Addendum #001

Date: December 2, 2022
To: City of Austin Historic Landmark Commission
From: Sanders Architecture, PLLC
Regarding: Window replacement scope

Sooch Residence

706 Oakland Ave.
Austin, TX 78703

G0.01

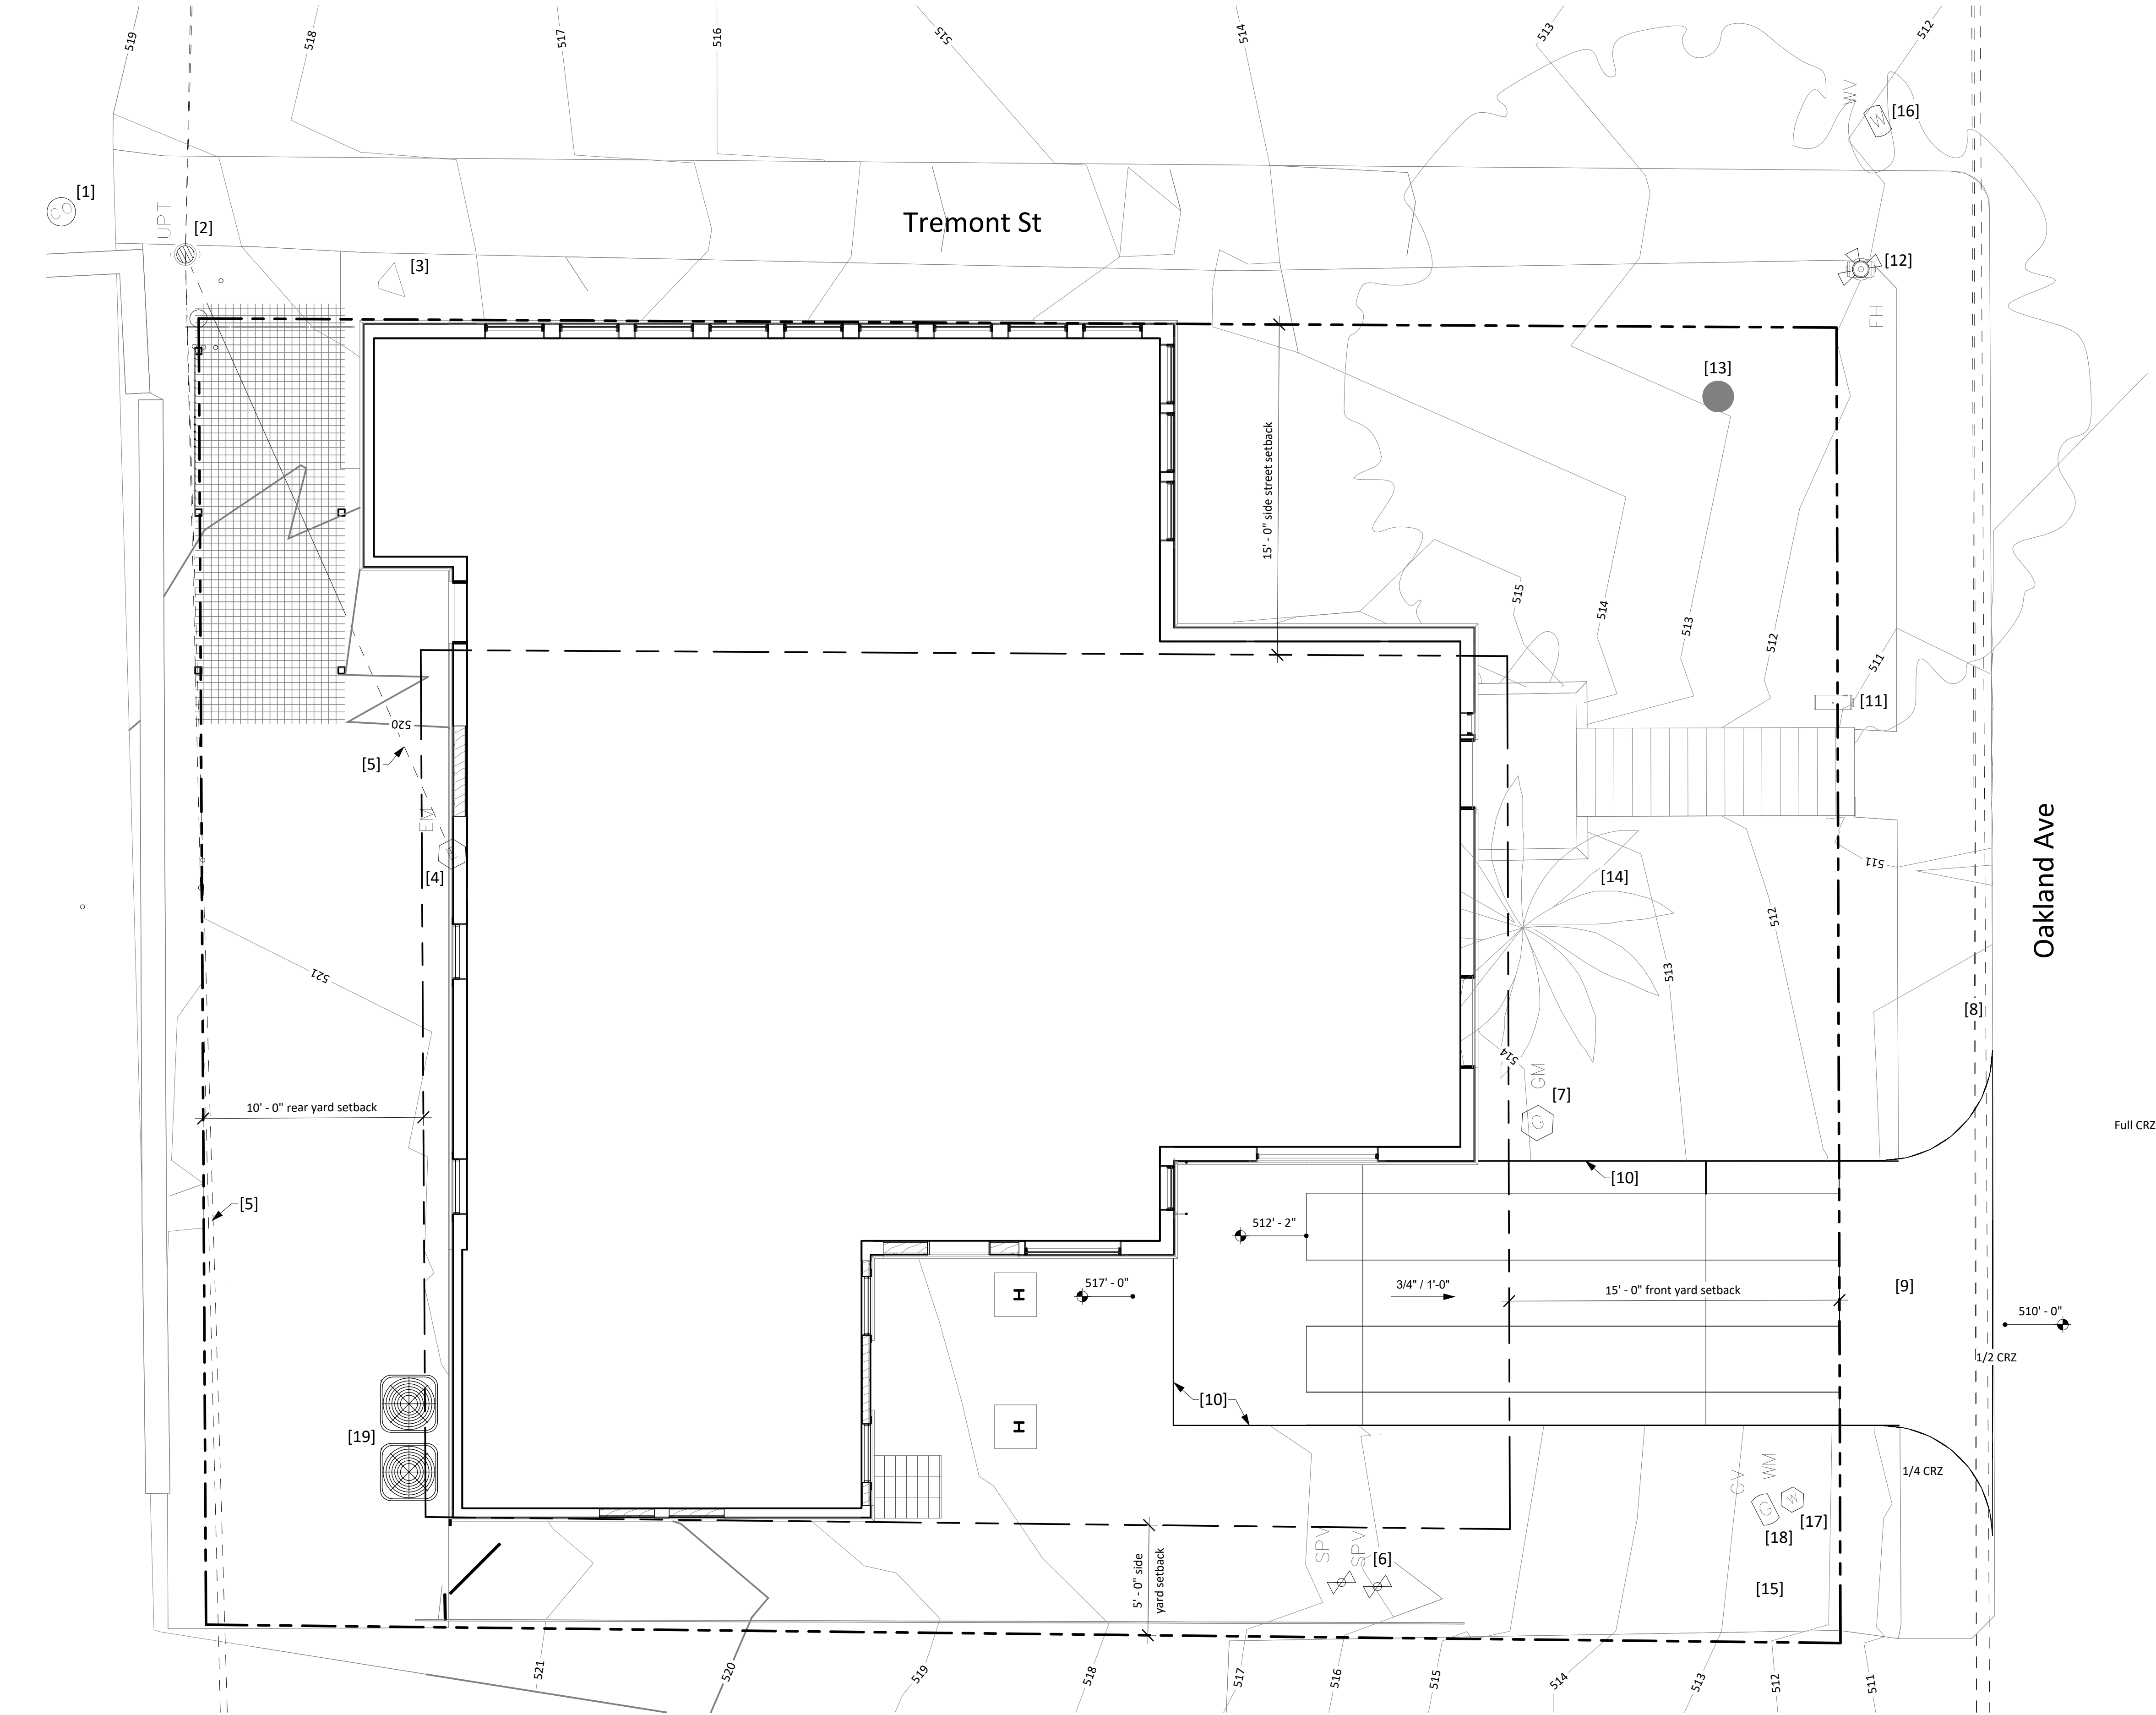
1. G0.01 – Keynote regarding replacing existing windows and corresponding annotations removed. Keynote regarding restoring stained glass as required and corresponding annotations removed.

G2.60

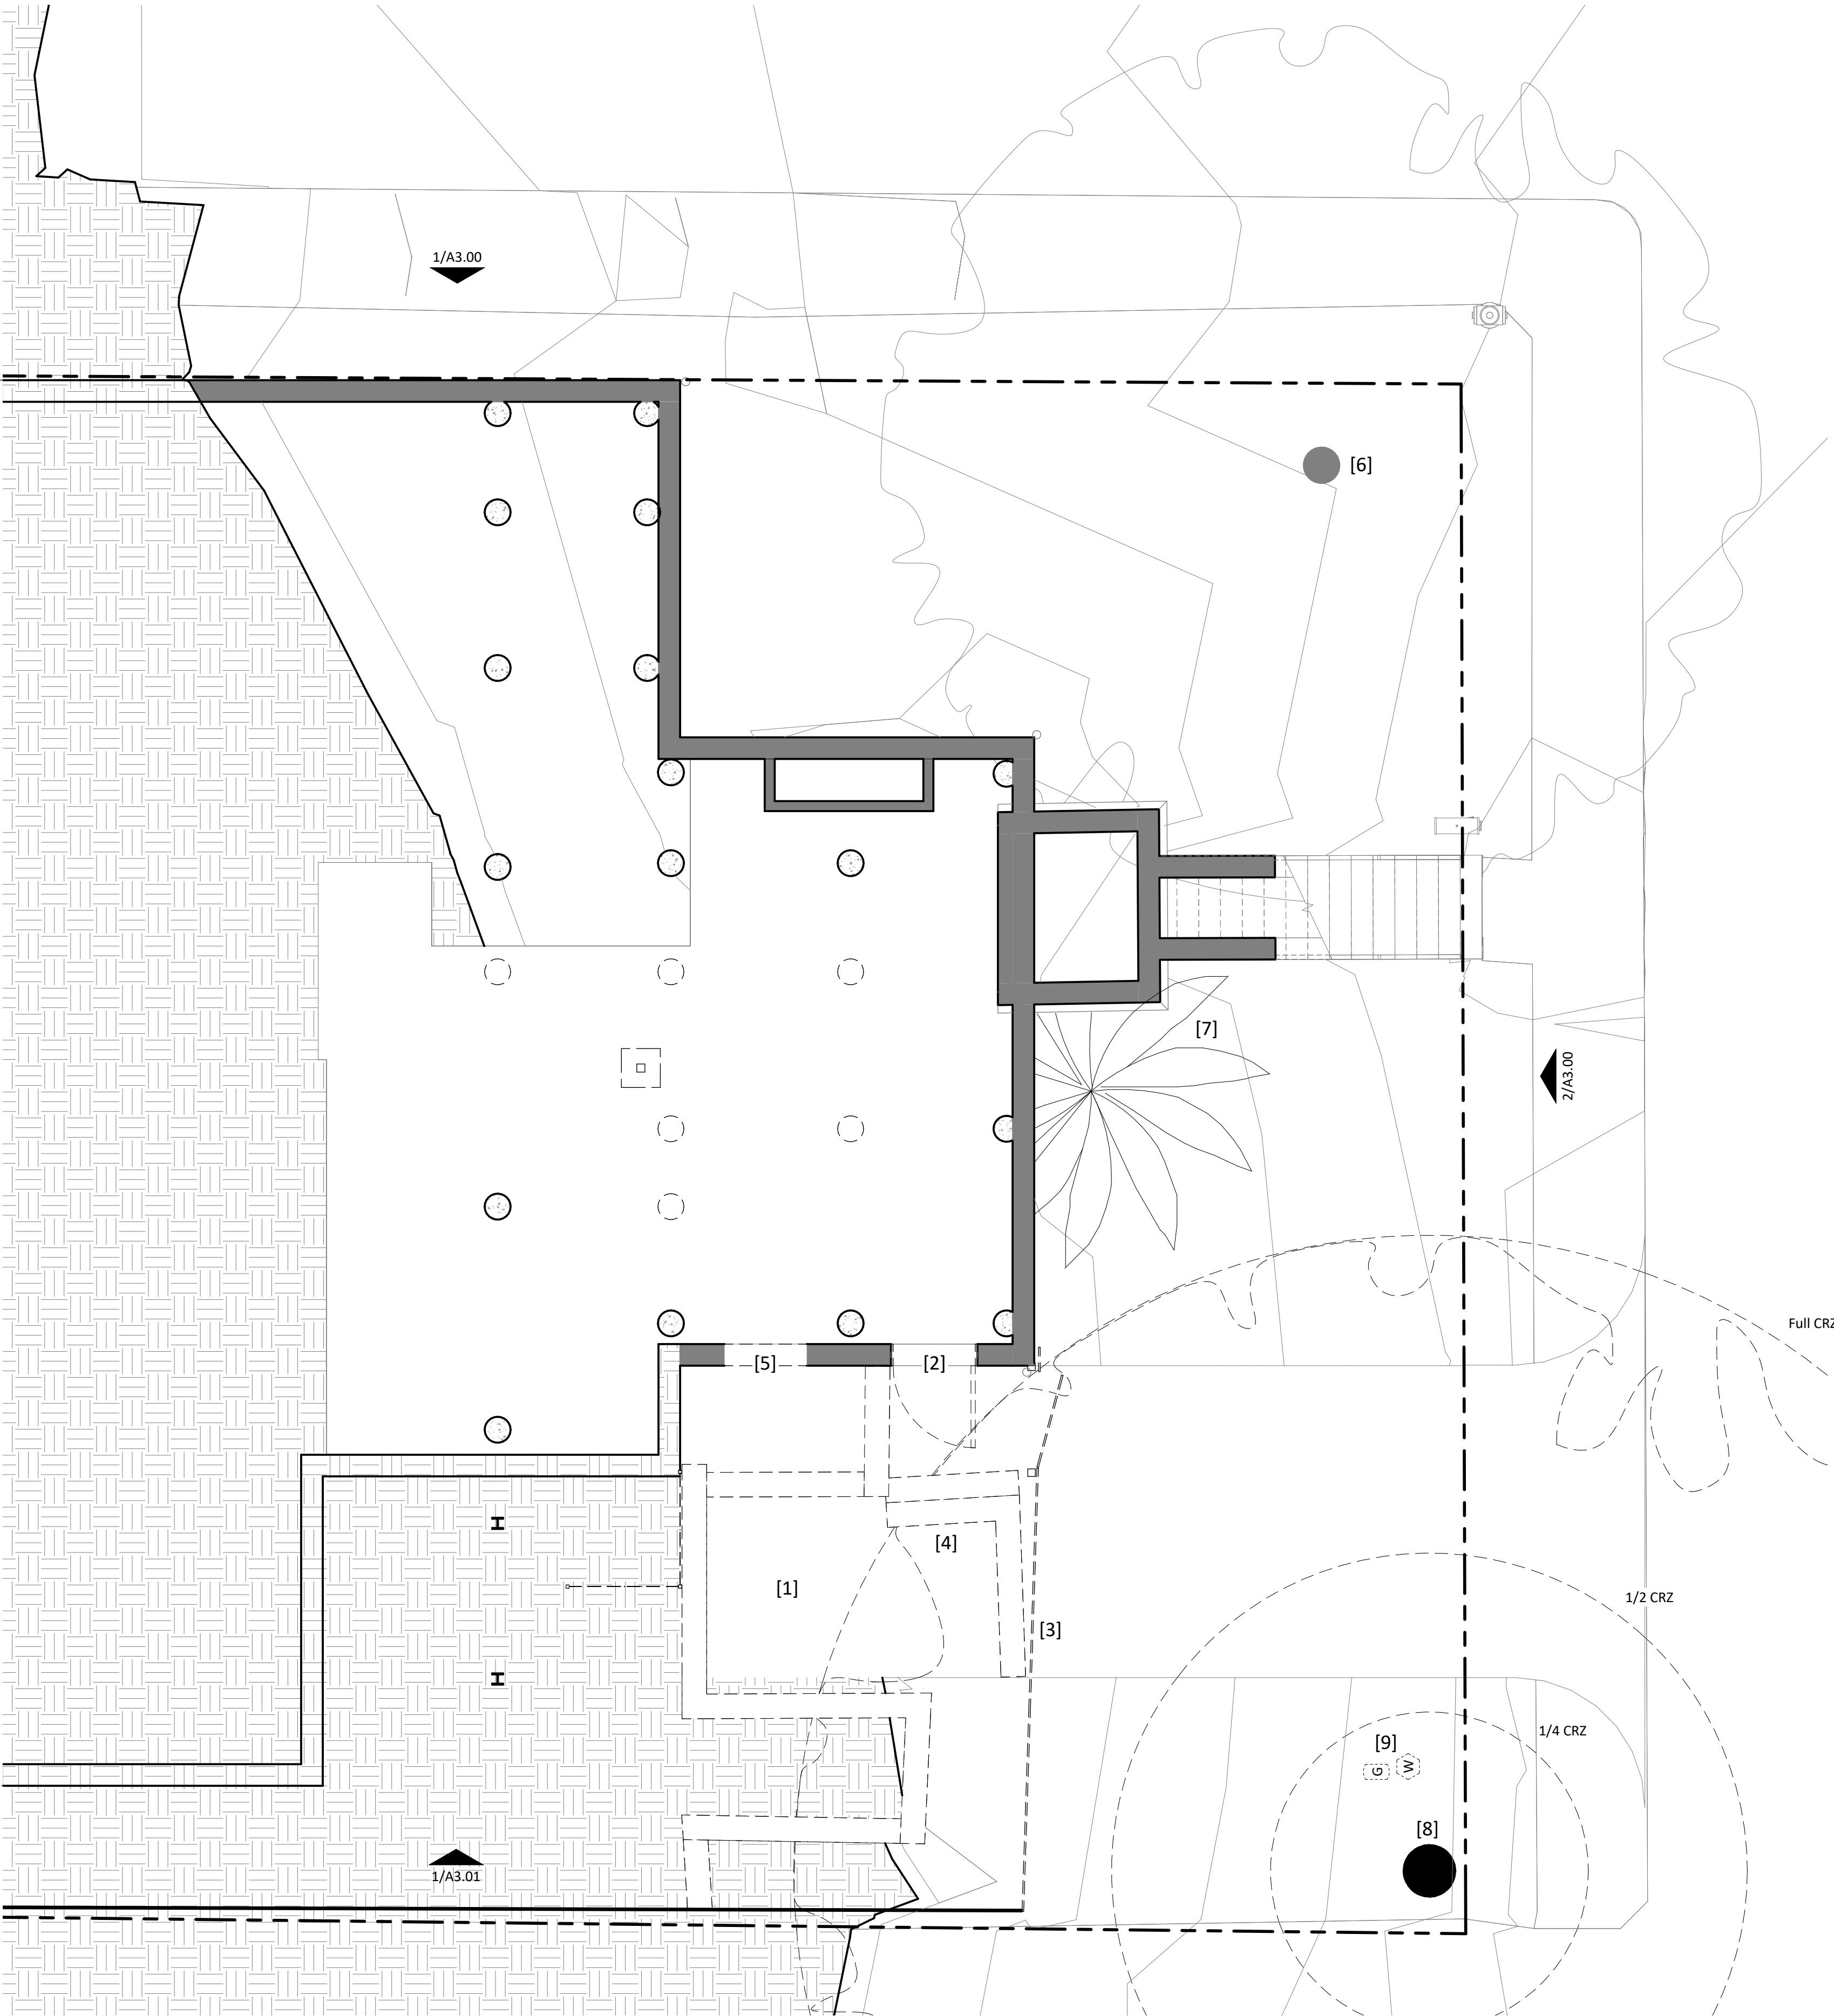
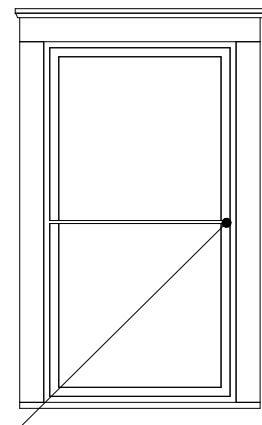
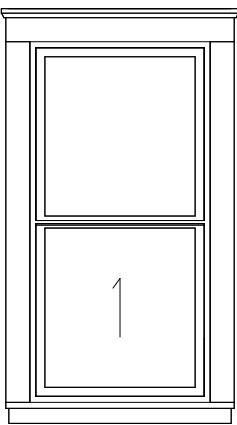
2. G2.60 – Elevations of previously proposed replacement windows and corresponding images removed. Details of existing and previously proposed windows removed.

A1.01

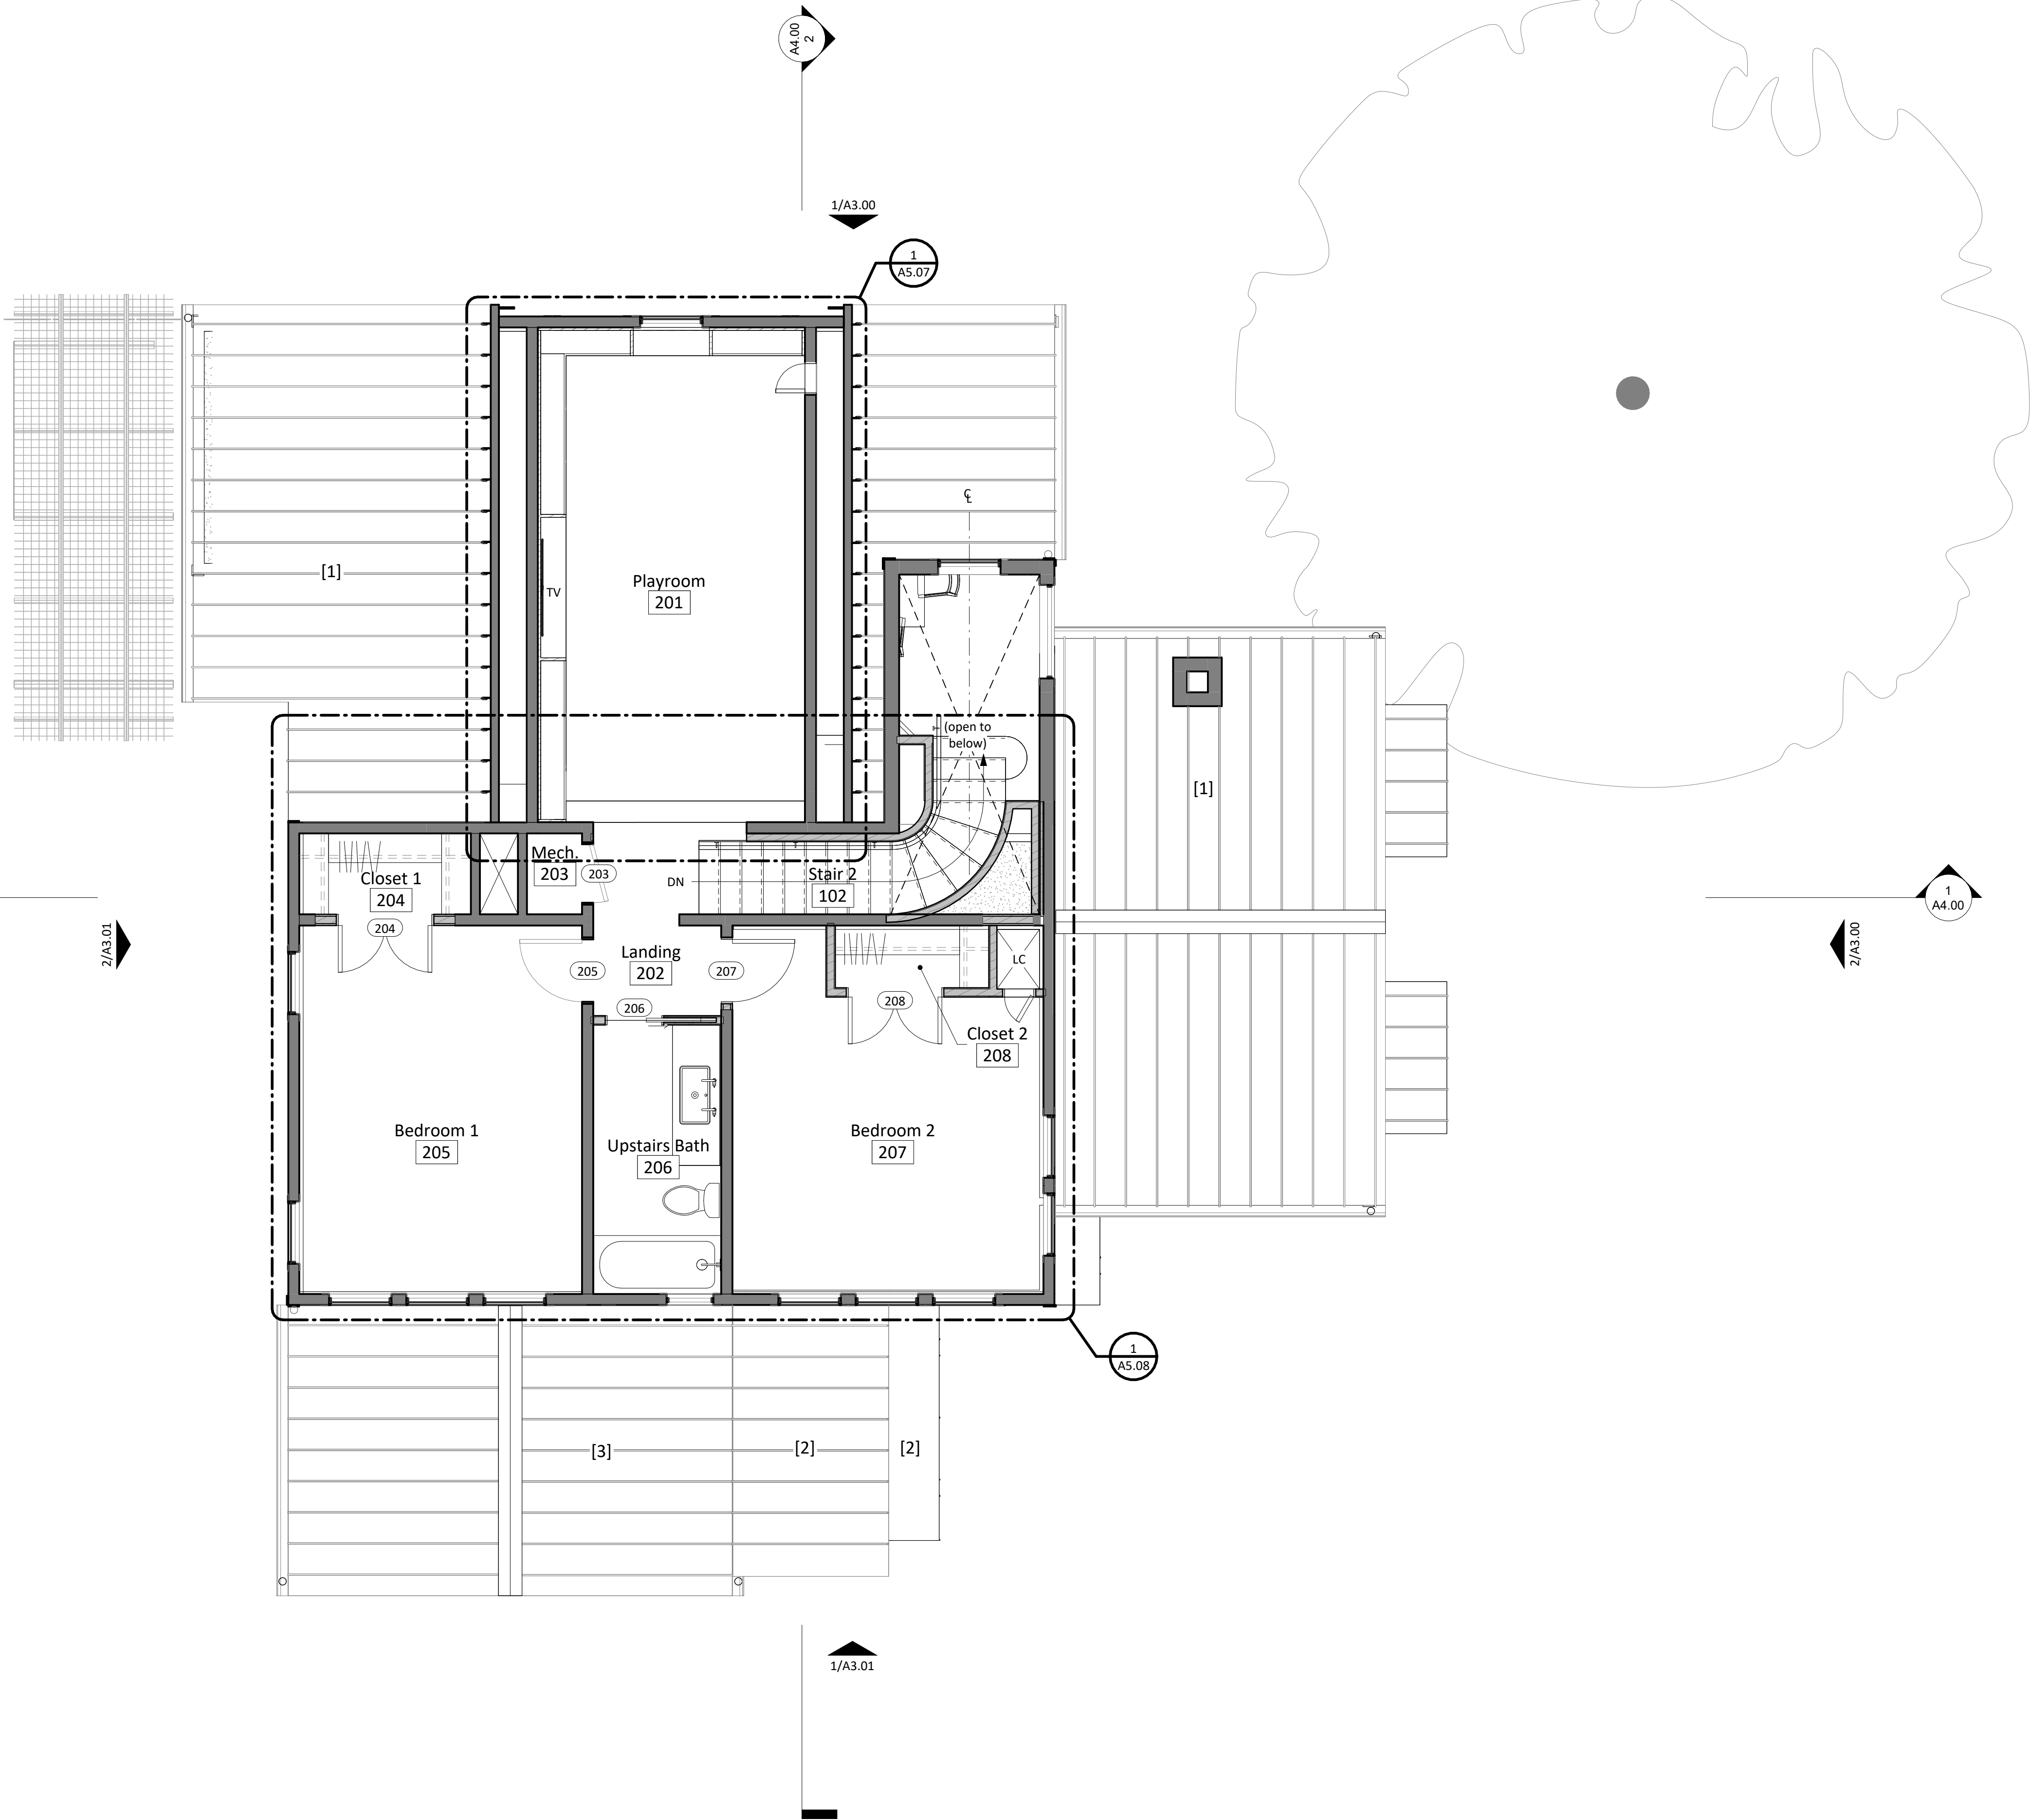
3. A1.01 – Previous replacement window tags removed. Keynote regarding replacing existing windows and corresponding annotations removed. Keynote regarding restoring stained glass as required and corresponding annotations removed.
